RFP NNK15549749Q - KSC RAIL SYSTEM OPERATIONS

Questions

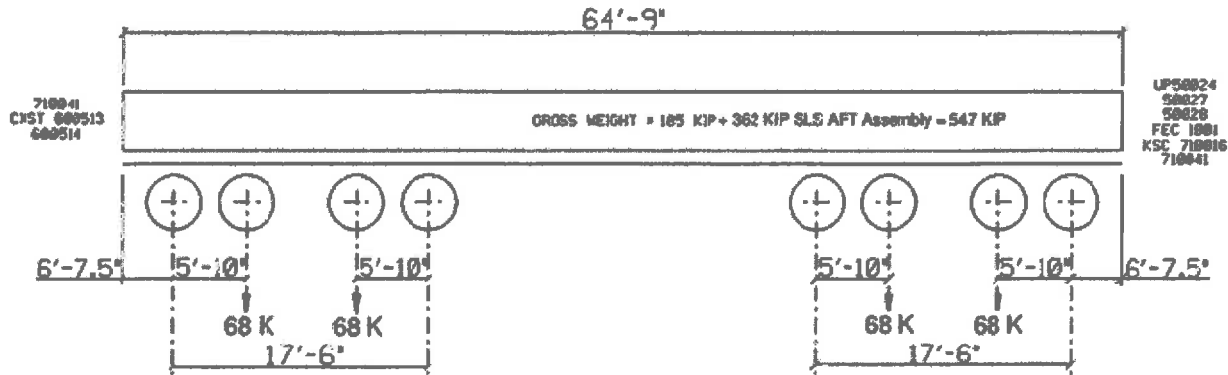
1. What is the total length of the SRB segment car?

2. What is the total weight of the segment car along with the car weight added for a total car/segment load weight?

See Diagram.

The maximum car/segment load weight depends on the load distribution on a particular car in a particular train and what order the cars are in. The SLS Aft Assembly car (see diagram above), with booster segment, weighs 547 KIP (kilo Pound) or 547,000 lbs. See NNK15549749Q, Statement of Work - REV. 1, Section 5.
